Permitting decisions

Variation

We have decided to grant the variation for Silt Lagoons at Rainham and Wennington Marshes operated by Land & Water Remediation Limited.

The variation number is EPR/FB3701XY/V002.

Figure 1 – Conceptual Model

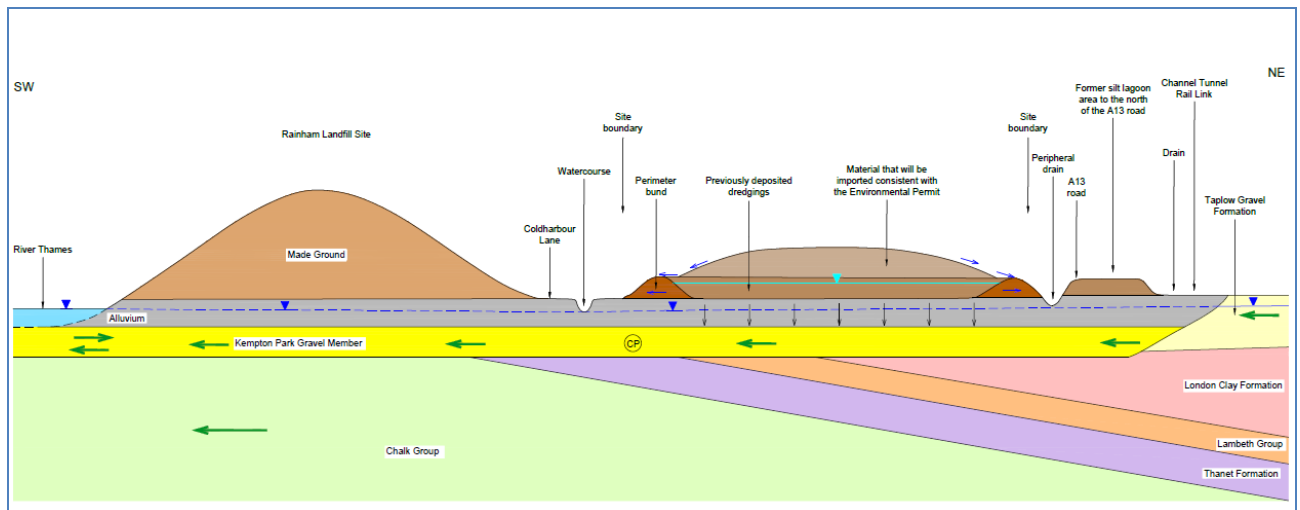
We considered that both conceptual models for the hydrogeological risk assessment (HRA) and stability risk assessment (SRA) submitted as part of the variation application needed to be reviewed, amended and to be consistent.

We considered that the key conceptual features of the existing situation and proposed landfill scheme had not been separately and adequately presented and justified.

The combined surface water and groundwater features needed to be shown on a map to understand the degree of interaction between waste, the carrier water, supernatant water (surface water run-off), groundwater and surface water and this would be facilitated by the additional information from the new boreholes installed (see Section 5a) above).

The HRA conceptual model did not address that it was likely that there would be a consolidation of the existing wastes, which vary in nature and grain size from one part to another, and of the alluvium substrata by the load imposed by the proposed wastes. It also did not appear to consider that consolidation over time may result in pore fluids being squeezed out of the wastes and alluvium into more permeable horizons and towards the perimeter drains and to groundwater.

There appeared to be differences in key features common to both conceptual models for the HRA and the Stability Risk Assessment (SRA).

The revised conceptual model details were submitted with the Schedule 5 response (full details in Section 2 of Response to the Notice of Request for More Information for Environmental Permit Application Number EA/EPR/FB3701XY/V002), which further informs and revises the HRA. This was

found to be satisfactory as originally it was not clear whether the contamination within the alluvium could be squeezed out and impact the groundwater. The revised HRA conceptual model accounts for this possibility.

The HRA conceptual model cross sections have also been updated in light of the information from the new boreholes, BH03 and BH04, (Figure 4 and Appendix B in Response to the Notice of Request for More Information for Environmental Permit Application Number EA/EPR/FB3701XY/V002). This, and the additional information supplied, has improved our understanding of the conceptual model and has sufficiently added to the HRA conceptual model for us to be able to be confident that it is an accurate representation of the site.

Therefore, we are satisfied that the revised HRA conceptual model accurately reflects the site.
